Request: BUILDING PERMIT

4-A-25-TOB

Purpose of Request: New warehouse building

DECK STORE WAREHOUSE NEW COMMERCIAL CONSTRUCTION

DRAWN BY: PB
 LANDSCAPE PLAN

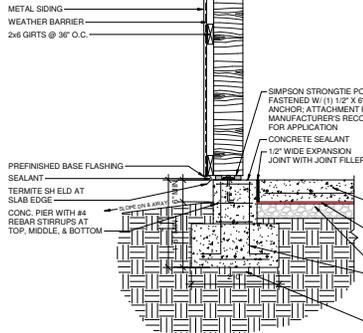
2. The proposed materials are board and batten metal siding with a metal roof and will both be a muted color. The proposed building would be 16 ft tall to the roof line. It does feature a long, unbroken facades, which is discouraged. However, in this instance, the building is not visible from the street. It would be mostly screened from the street by buffer yard landscaping of holly and arborvitae trees along Cogdill Rd and the interstate. Schipka Laurel evergreen shrubs will be planted around the front and entrance to the building. The landscaping plan meets the Design Guidelines.

1 SITE PLAN - LIGHTING
 E200 1" = 30'-0"

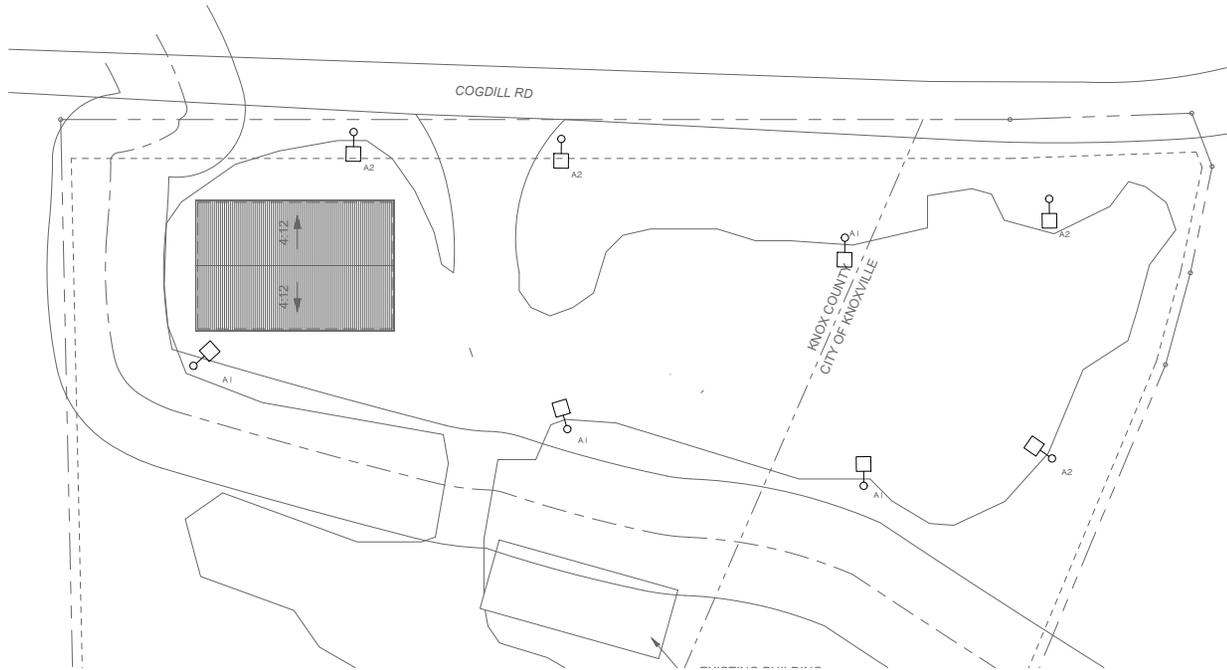
5. The lighting plan meets all TTCDA guidelines for lighting intensity. Eight light poles with a dark color are being added to the property. The footcandles are 0-0.1 at the property lines.
